**PROPOSED GREEN FUEL STATION (ELECTRIC VEHICLE CHARGING) AND SHOP AND  
SERVICES (CONVENIENCE STORE) AT WORKSHOPS 7 & 8 ON GROUND FLOOR,  
METRO CENTRE, 32 LAM HING STREET, KOWLOON BAY, KOWLOON**

**Planning Application No. A/K13/334 – Further Information (5)**

**Consolidated Report**

**Attachment 1: Response-to-Comment Table (Departmental Comments)**

### **Swept Path Analysis**

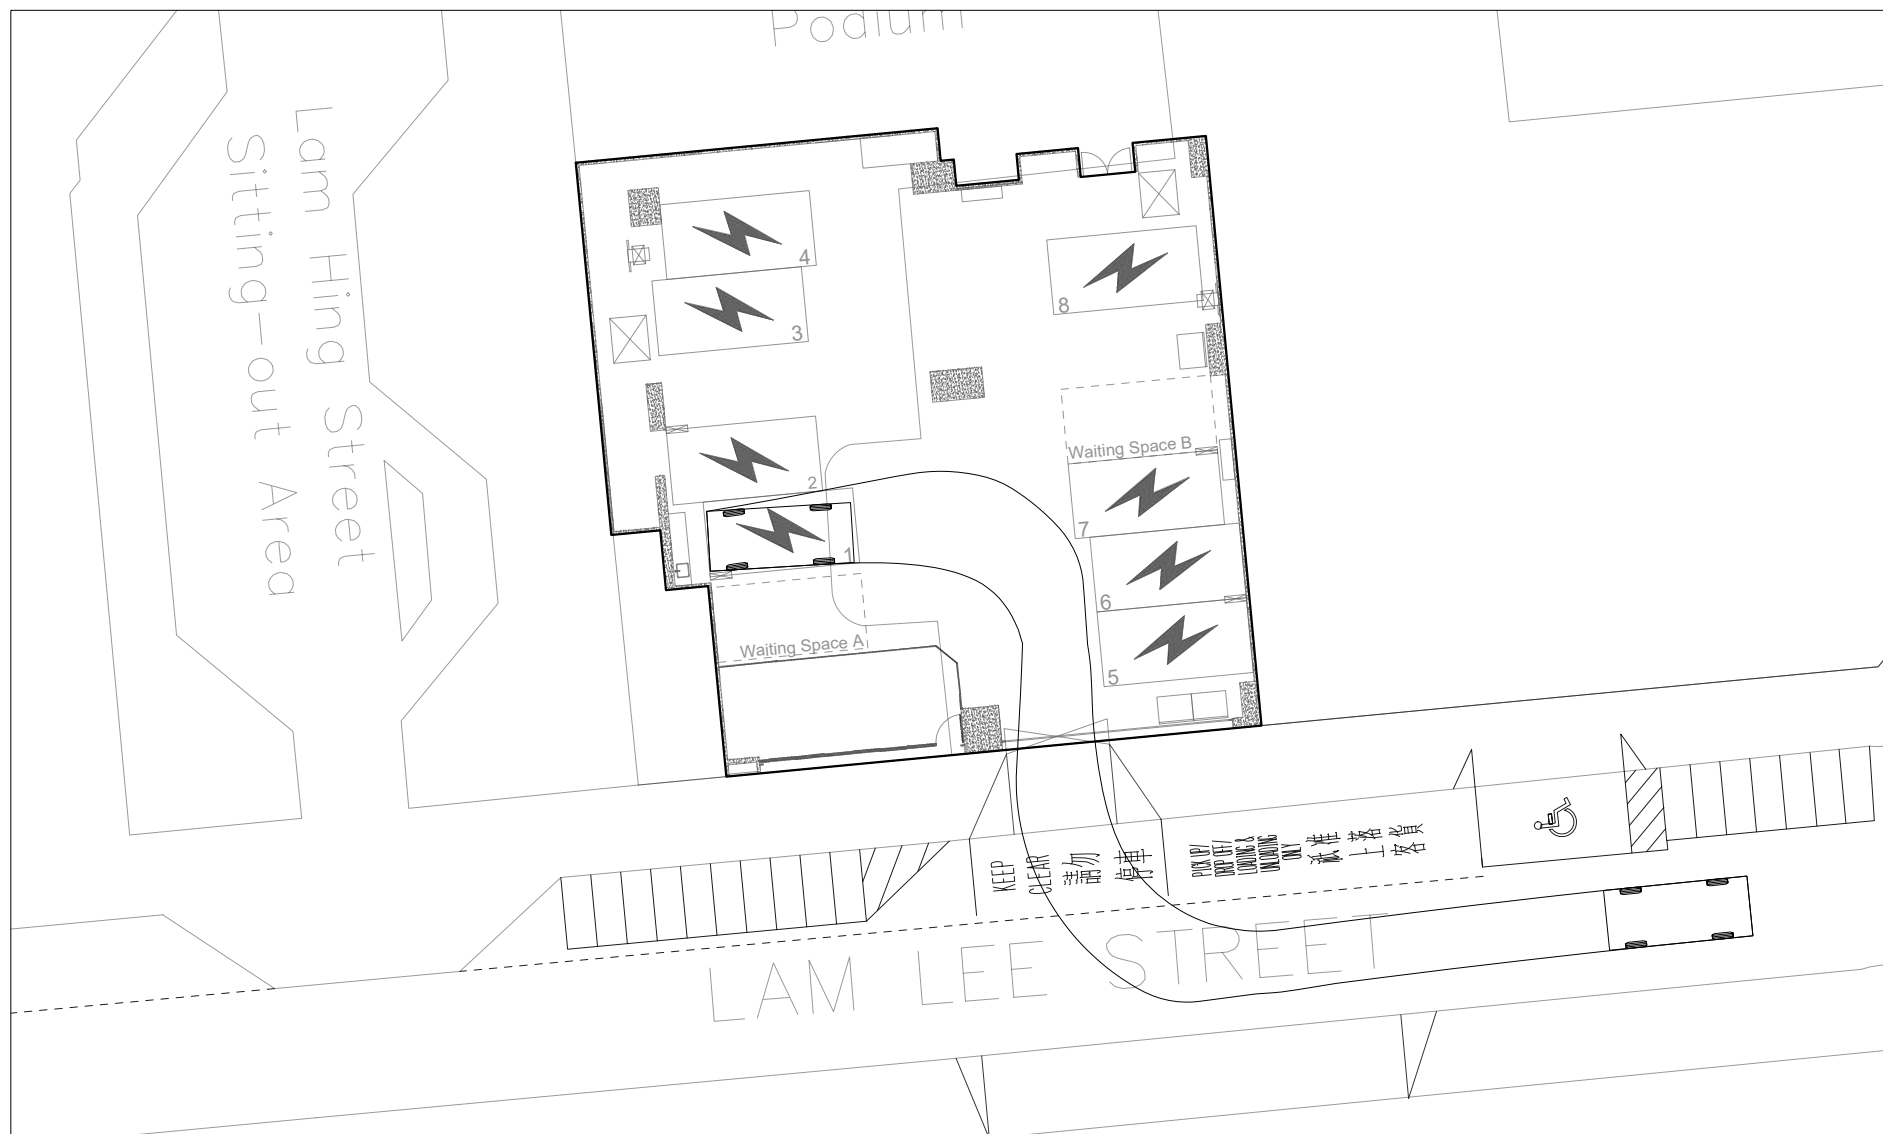
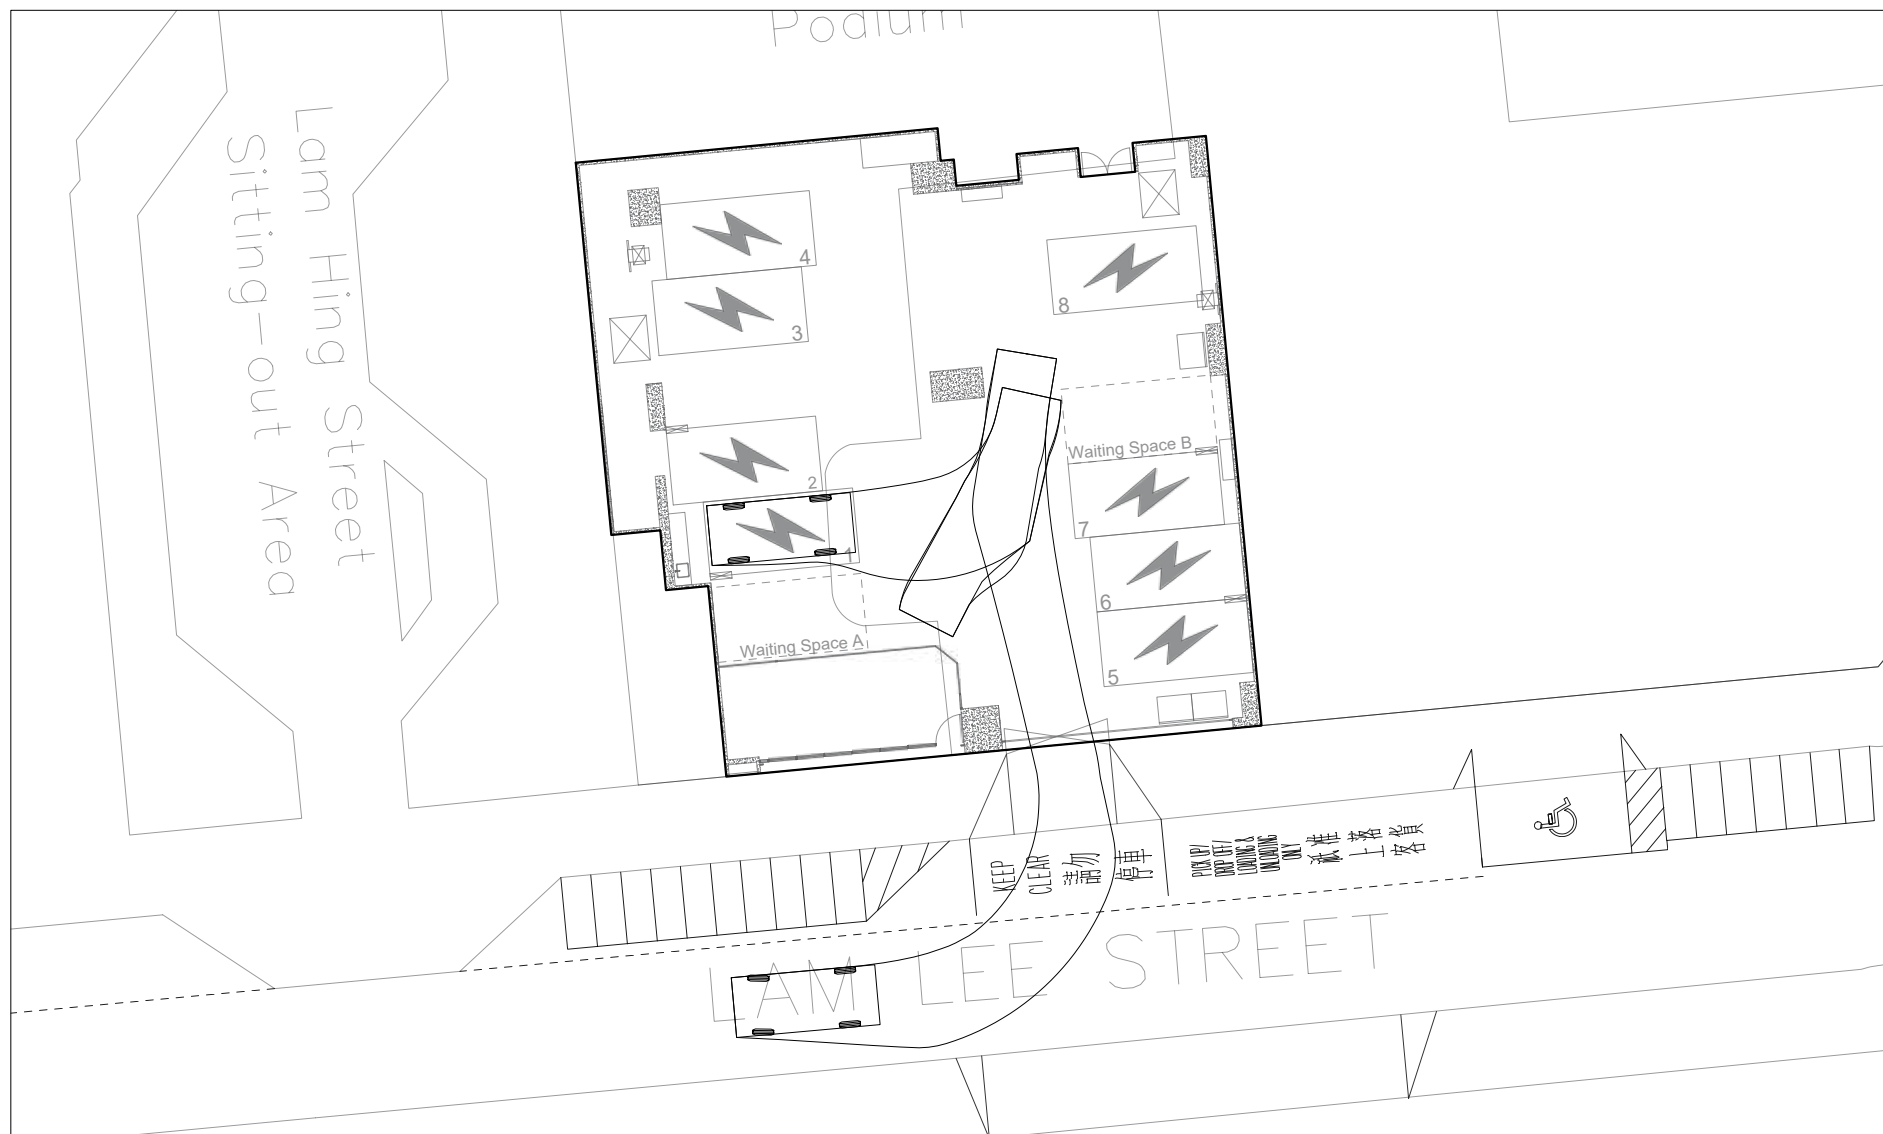
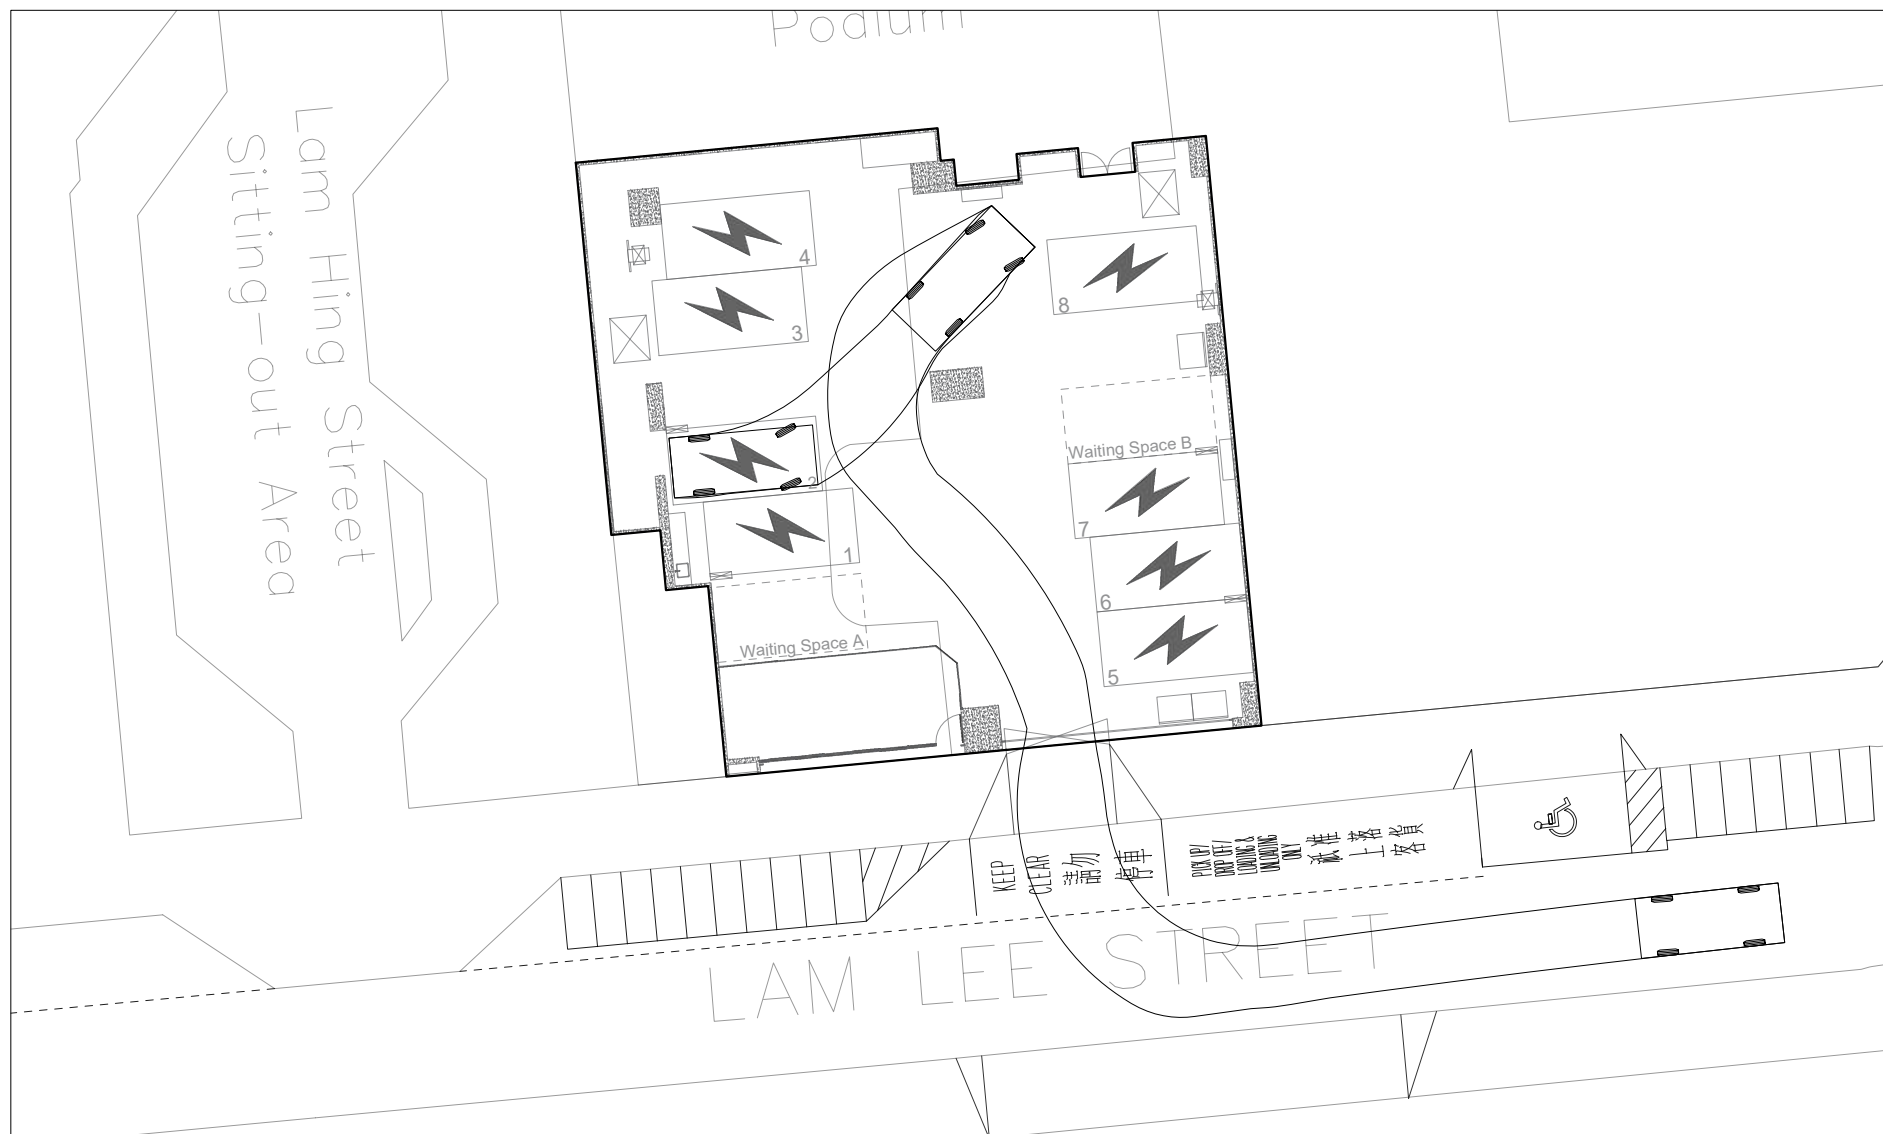
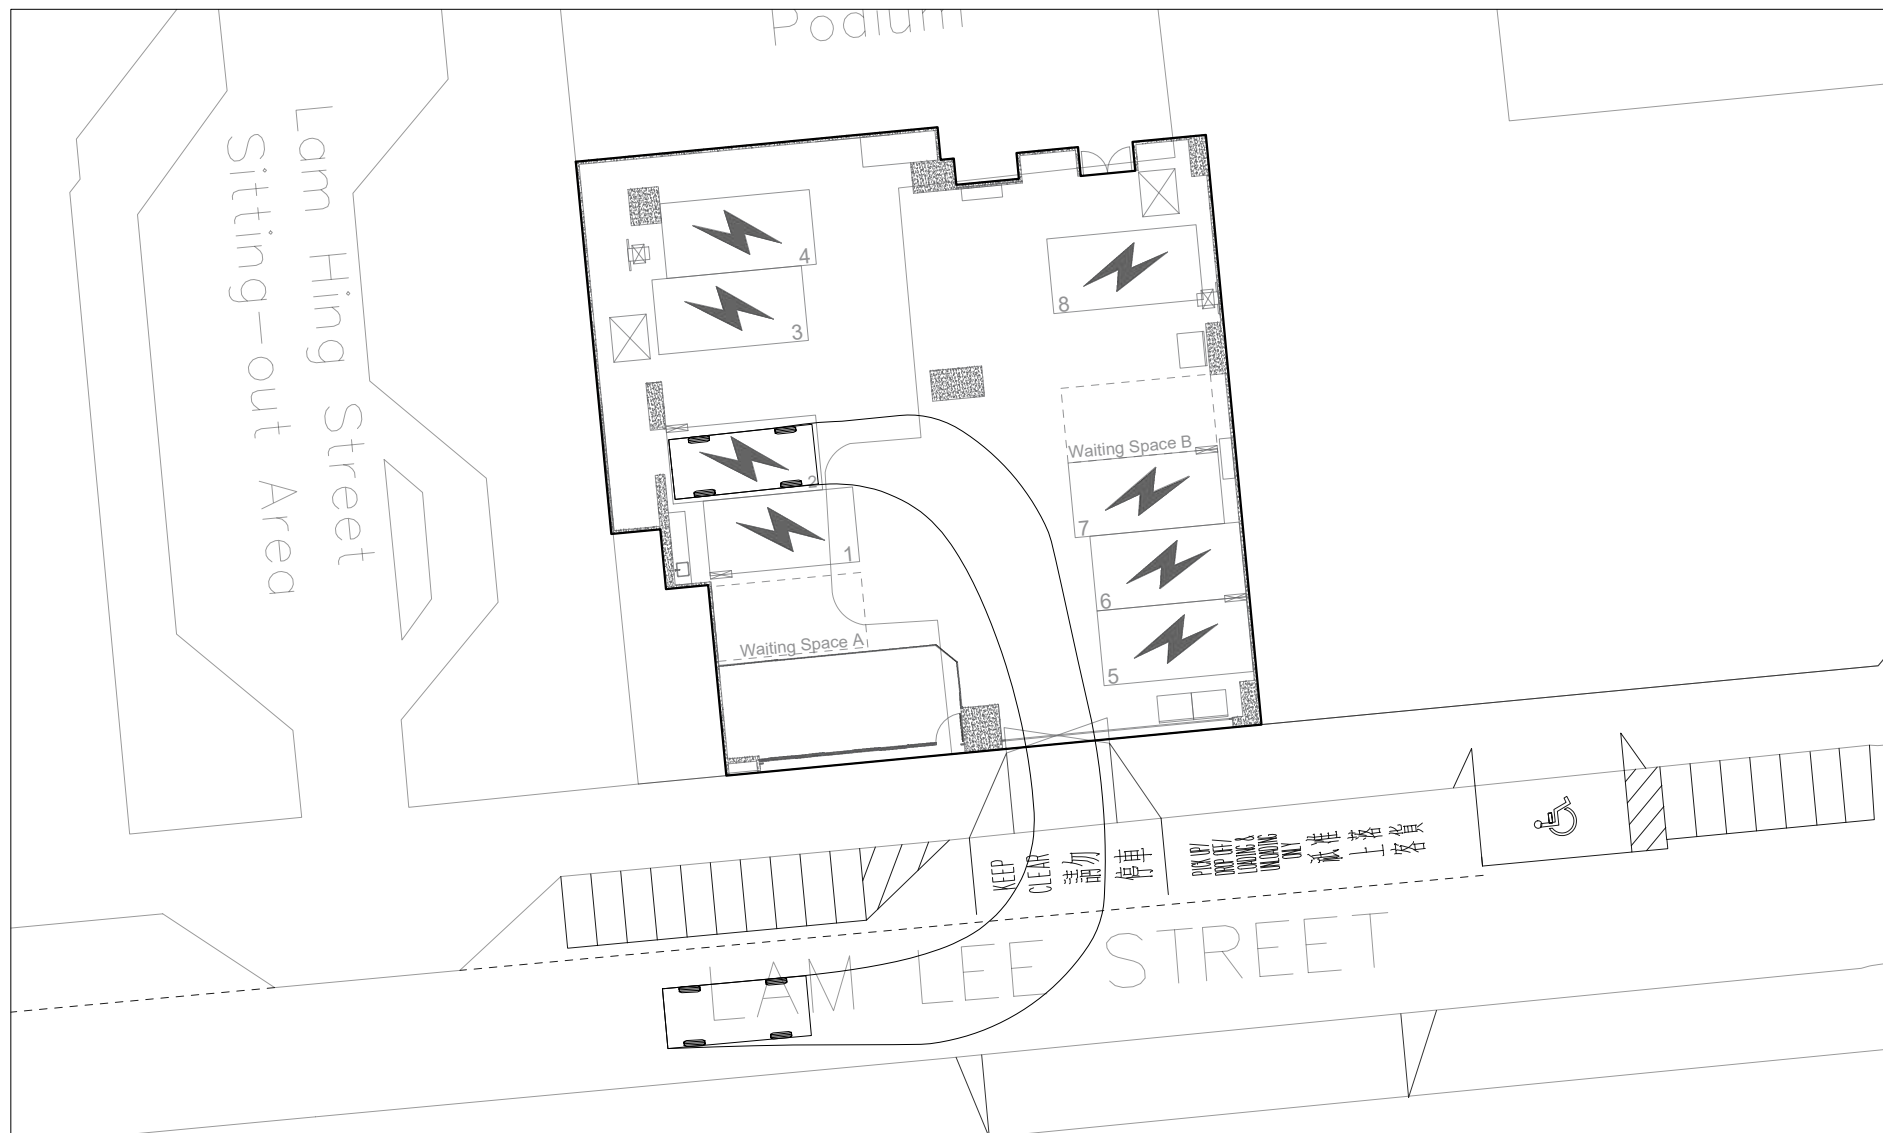
| <i>Departmental Comments</i>                                                                                                                                                                                                                                                                                                                                                                                                                                                                                                                                                                                                                                                                                                                                       | <i>Response</i>                                                                                                                                            |
|--------------------------------------------------------------------------------------------------------------------------------------------------------------------------------------------------------------------------------------------------------------------------------------------------------------------------------------------------------------------------------------------------------------------------------------------------------------------------------------------------------------------------------------------------------------------------------------------------------------------------------------------------------------------------------------------------------------------------------------------------------------------|------------------------------------------------------------------------------------------------------------------------------------------------------------|
| 1. The swept path analyses of the vehicle entering and leaving the EV charging spaces No. 1, 3, 6, 7 and 8 as well as the waiting spaces No. 1 and 2 are missing. Please provide those swept path analyses for further review.                                                                                                                                                                                                                                                                                                                                                                                                                                                                                                                                     | Please refer to <b>Appendix A of Attachment 2 – Revised Traffic Review Report</b> for the swept path analyses of all charging spaces and waiting spaces.   |
| 2. The backward movement of vehicles on the public road for entering the EV charging space No. 2 of the Premises was noted based on the swept path analyses as enclosed in Appendix A of the Traffic Review Report. We do not support it from traffic engineering perspective, which such backward movement of vehicles on the public road for entering the Premises may pose potential danger and raise road safety issues to the road users. Please review and revise the swept path analyses, and also                                                                                                                                                                                                                                                          | Noted. Please refer to <b>Figure 3 in Appendix A of Attachment 2 (p.25)</b> , showing the revised swept path of the vehicle entering charging space No. 2. |

| <i>Departmental Comments</i>                                                                                                                                                                                                                                                                                                                                                                                                                                                                                                                                                                                                                                                                                                                                                                                                                                                                                                                                                                                                                                                        | <i>Response</i>                                                                                                                                               |
|-------------------------------------------------------------------------------------------------------------------------------------------------------------------------------------------------------------------------------------------------------------------------------------------------------------------------------------------------------------------------------------------------------------------------------------------------------------------------------------------------------------------------------------------------------------------------------------------------------------------------------------------------------------------------------------------------------------------------------------------------------------------------------------------------------------------------------------------------------------------------------------------------------------------------------------------------------------------------------------------------------------------------------------------------------------------------------------|---------------------------------------------------------------------------------------------------------------------------------------------------------------|
| 2. As referring to the swept path analyses in the revised traffic review report, it is noted that reverse movement of the private car from the public road to the captioned EV charging station would not be required. However, it only shows the swept path of the private car from the waiting space A to the charging space no. 8 as well as the swept path of the private car from the waiting space B to the charging space no. 1. Please supplement the swept path analyses of the private car from the waiting space A to all the other charging spaces. Similarly, please supplement the swept path analyses of the private car from the waiting space B to all the other charging spaces. Please be noted that the drivers would wait at the waiting spaces once all the charging spaces in the EV charging station are full. Once the charging space is available, the driver at the waiting space should be able to access the vacant charging space (i.e. can be any of the charging space no. 1 to 8) without requiring to have reverse movement onto the public road. | Noted. Please refer to the revised swept path analyses in <b>Attachment 2</b> for your reference.                                                             |
